ALERT SERVICE BULLETIN

505-24-42

MODEL AFFECTED: 505

SUBJECT: TAIL ROTOR PITCH LINK ASSEMBLY
INSTALLATION, ONE-TIME INSPECTION OF.

Figure 1 – Tail Rotor Pitch Link Assembly Installation

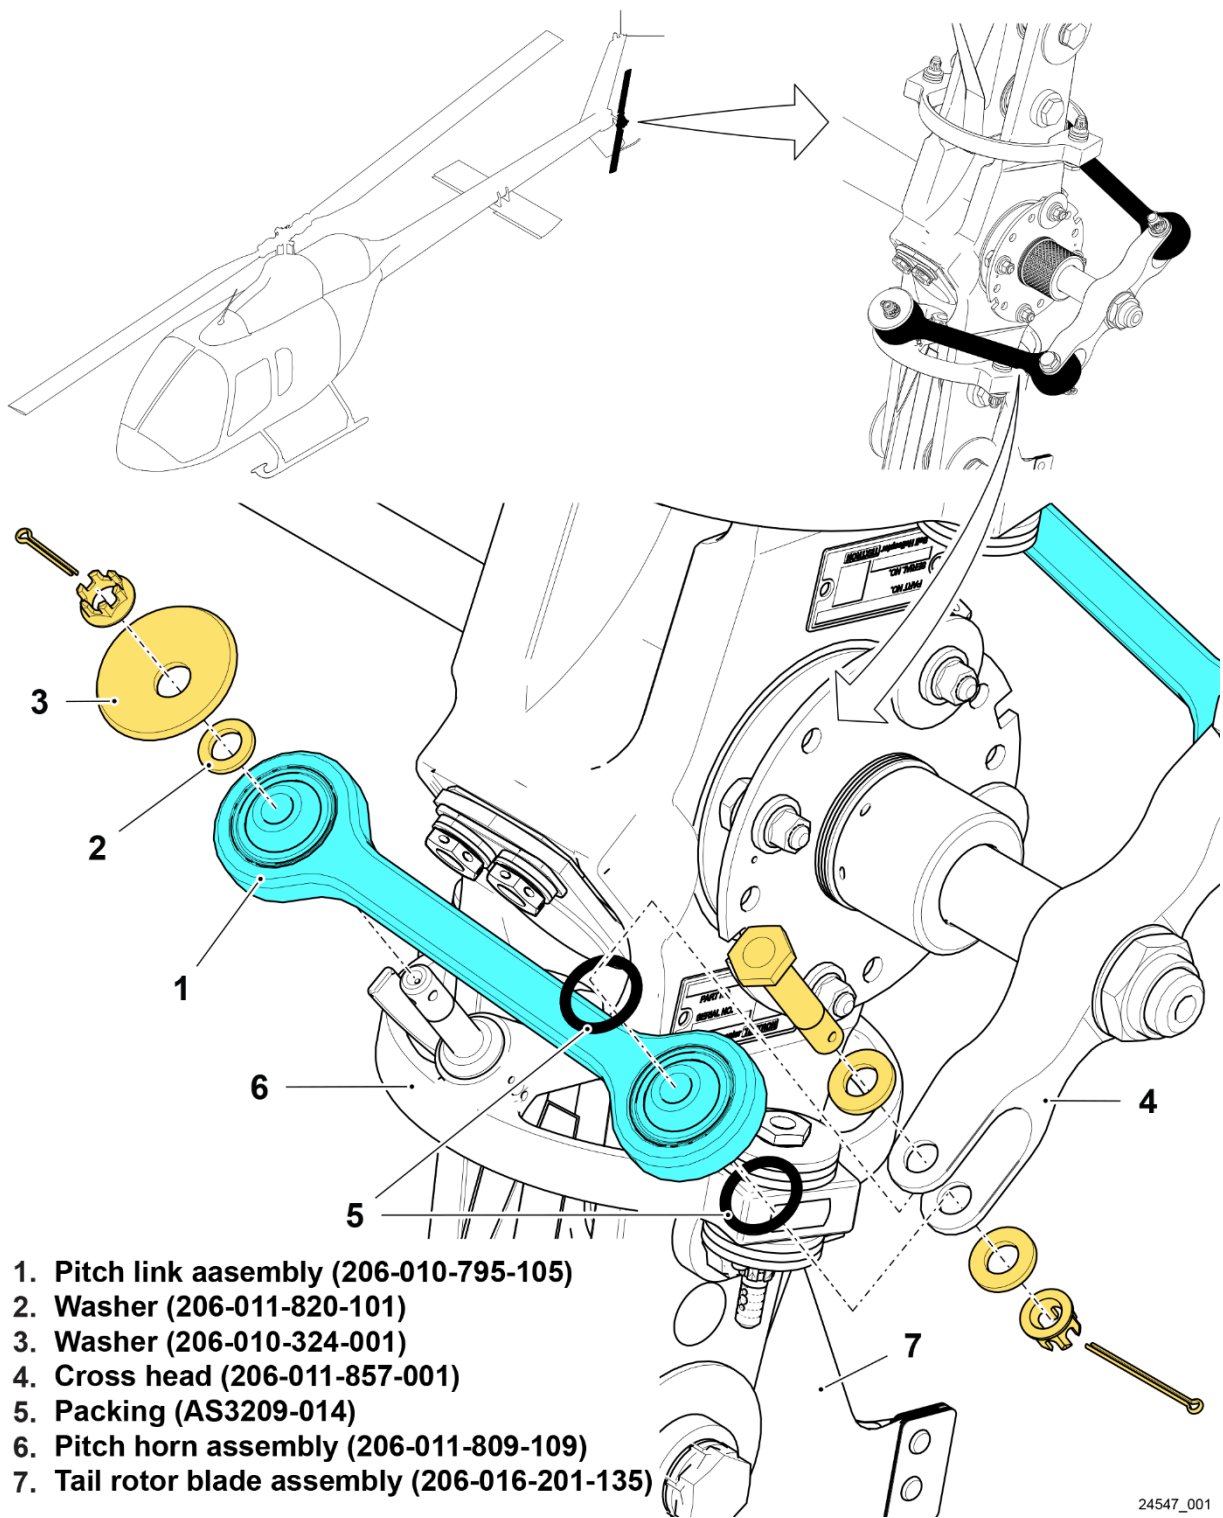
2. Inspect the tail rotor pitch link assembly (1) installation for proper installation of washer (2). The washer (2) is to be between the pitch link assembly (1) and the conical washer (3).

- a. If washer (2) is installed in the proper location, go to step 6.
 - b. If washer (2) is installed in the wrong location, between the tail rotor pitch link assembly (1) and the pitch horn assembly (6), go to step 3.

3. For tail rotor pitch link assemblies (1) with improperly installed washer (2), visually inspect the affected tail rotor pitch link assembly (1) for **any** signs of contact between the pitch link assembly (1) and conical washer (3) or pitch horn assembly (6).

4. Remove pitch link assembly(s) (1) ([DMC-505-A-64-30-02-00A-520A-A](#)).
5. Install pitch link assembly(s) (1) with the correct location of washer (2) and conical washer (3) (Figure 1 and [DMC-505-A-64-30-02-00A-720A-A](#)).

2. Remove and discard tail rotor pitch link(s) (1, Figure 1) that had signs of contact found in step 3.b. of **PART I**.
3. Remove and discard packings (5).
4. Remove and discard conical washer(s) (3).
5. Remove tail rotor blade assembly(s) (7) of associated pitch link assembly (1) that has been removed in step 2 ([DMC-505-A-64-10-01-00A-520A-A](#)).
6. Remove pitch horn(s) (6) from tail rotor blade assembly(s) (7) and discard ([DMC-505-A-64-10-01-00A-530A-A](#)).
7. Install new or serviceable pitch horn(s) (6) to tail rotor blade assembly(s) (7) ([DMC-505-A-64-10-01-00A-710A-A](#)).

8. Install tail rotor blade assembly(s) (7) ([DMC-505-A-64-10-01-00A-720A-A](#)).
9. Install new or serviceable tail rotor pitch link(s) (1) and packings (5) ([DMC-505-A-64-30-02-00A-720A-A](#)).
10. Install hardware to perform tail rotor dynamic balancing ([DMC-505-A-18-12-00-00A-330A-A](#)).
11. Dynamically balance the tail rotor assembly ([DMC-505-A-18-12-00-00A-370A-A](#)).
12. Remove tail rotor assembly dynamic balancing hardware ([DMC-505-A-18-12-00-00A-332A-A](#)).
13. Make an entry in the helicopter logbook and historical service records indicating compliance with **PART II** of this Alert Service Bulletin.
